**2.3: LOCAL PLANNING POLICY – MODIFICATIONS TO THE DETAILED
AREA PLANS POLICY – CLYDESDALE PARK, MCKAIL**

RE: PROPOSED DETAILED AREA PLAN – CLYDESDALE PARK ESTATE, ALBANY

DETAILED AREA PLAN R-CODE VARIATIONS

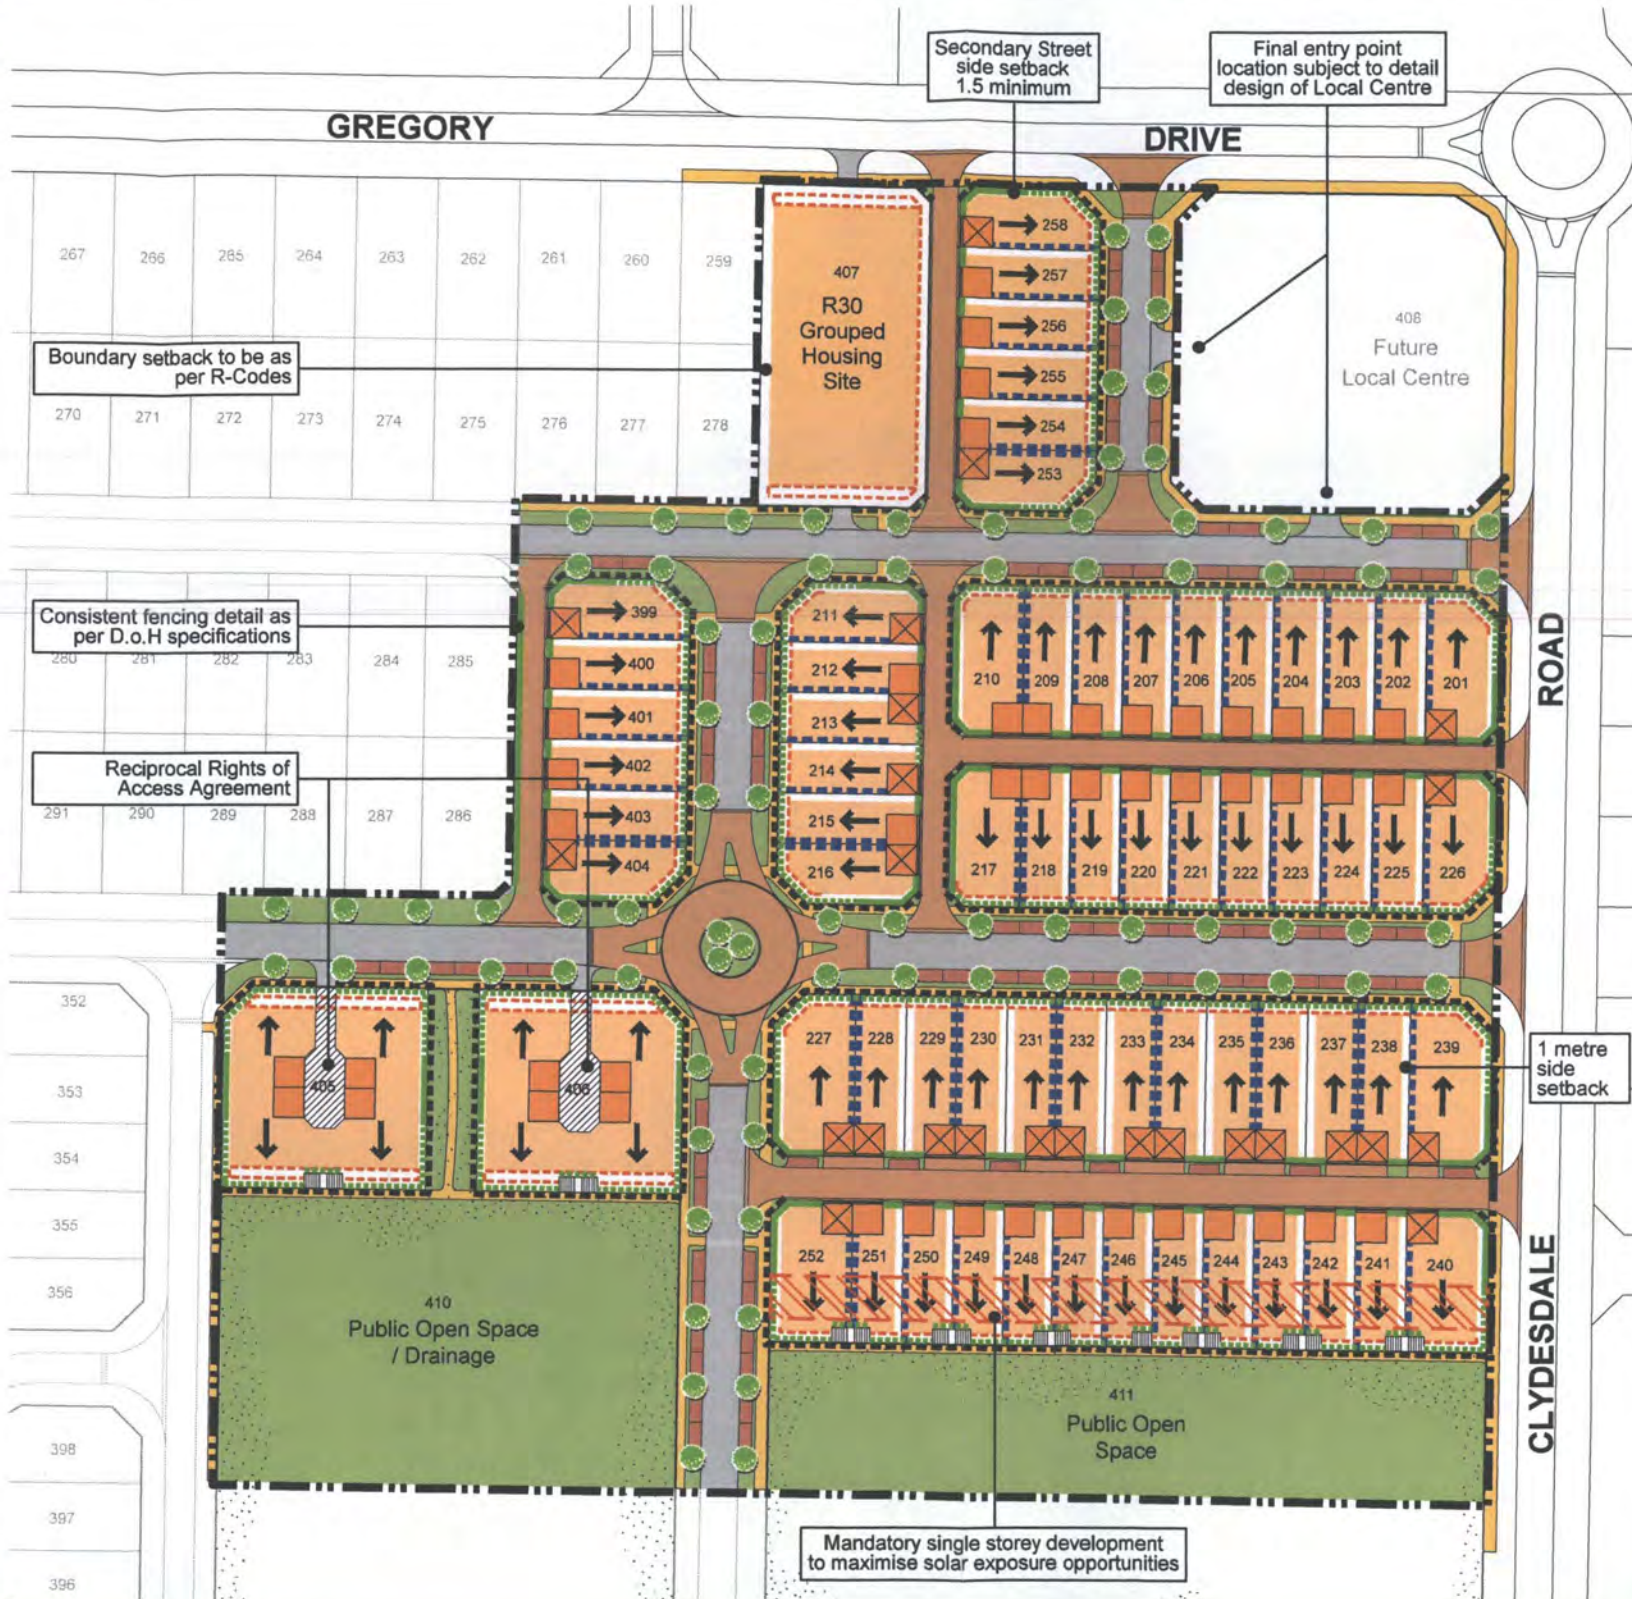
Relocate the position of the mandatory garage or carport locations for Lots 213 and 214 and illustrate a requirement for permeable estate fencing between the garage and the side lot boundary.

Review and update all applicable rear / laneway setbacks given the amendments that have been made to the extent of the drainage easements along the rear of several of the lots within the Estate.

Include a notation on Lot 407 stating that the ‘Boundary setback to be as per R-Codes’.

The previous DAP submitted illustrated a red-dashed line along the boundary of Lot 407, which was not applicable as such a line is only applicable for the primary street or POS setback. Therefore, the DAP has been updated to remove this line and to include a notation requiring that the boundary setback of this grouped housing site be as per the requirements of the R-Codes.
